**Review and Evaluation of
STMO Bn, LLC (Starfire)
Site Assessment Report
Case Number: 2024-00255**

May 26, 2025

Prepared for

Prepared by

Figure C-10.
Starfire Project Map of Delivery Routes and Internal Access Roads

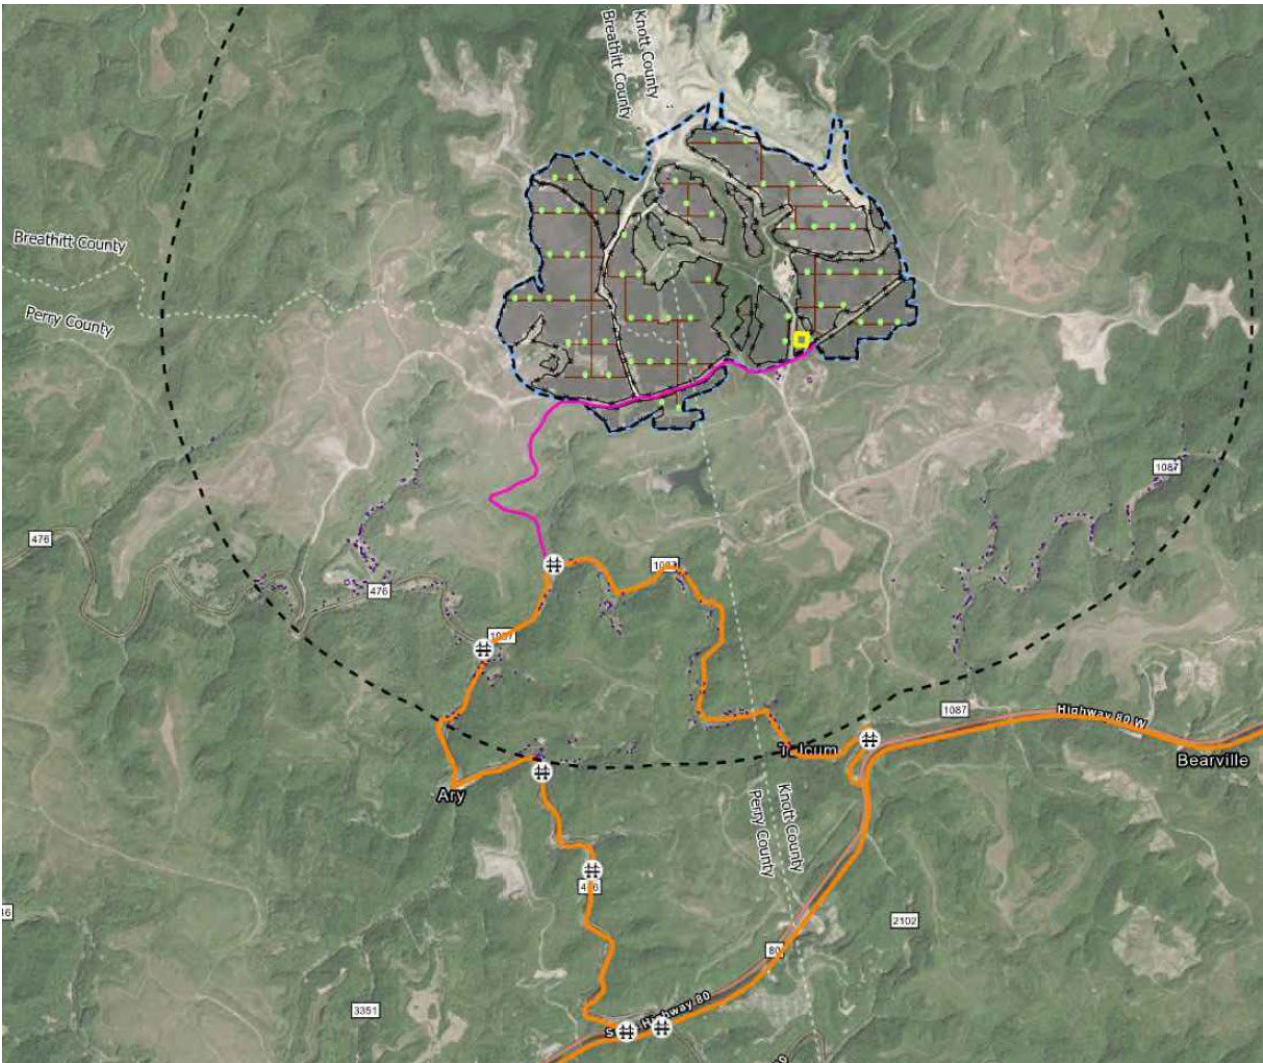
Location and use of access ways, internal roads, and railways. Page 3 of the SAR states that the locations of access ways and internal roads are depicted in Attachment 1, however BBC could not locate the information on the referenced map and the applicant was asked to supply an updated map in the First RFI.

Location and use of access ways, internal roads, and railways. Responding to the First RFI, the applicant supplied a directional map which is excerpted here as Figure C-10.

In Figure C-10, primary public roadways for vehicle traffic and load deliveries are highlighted in orange, while the proposed site access road is shown in purple. The proposed site access road currently exists but is blocked to through traffic at this time. Internal roads within the project boundary can be seen laid out in a grid pattern among the solar panel arrays.

Figure C-24.
Starfire Project Operational Acoustic Modeling Results

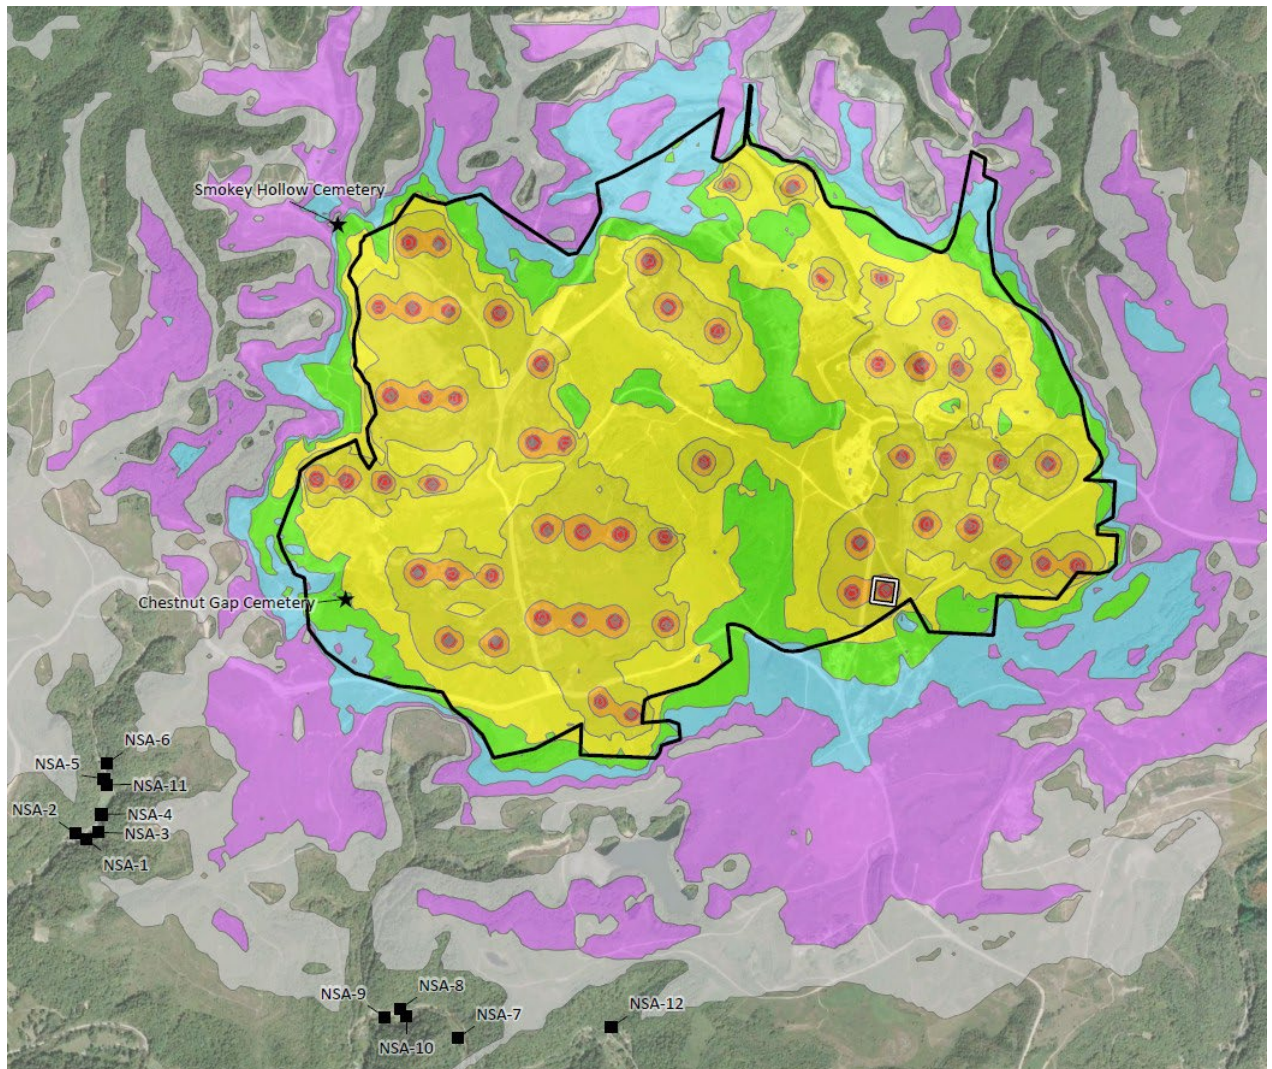
Figure C-24 presents the noise contour map for daytime operational noise during the proposed project's lifetime, excerpted from Attachment 4. Red dots within the project boundary (the black line) are indicative of the project inverters, and the substation is pictured with a red square icon on the southeastern boundary of the site. Noise sensitive receptors are indicated with black square icons in the southwestern area of the map, and no residential NSRs are within 2,000 feet of the project.
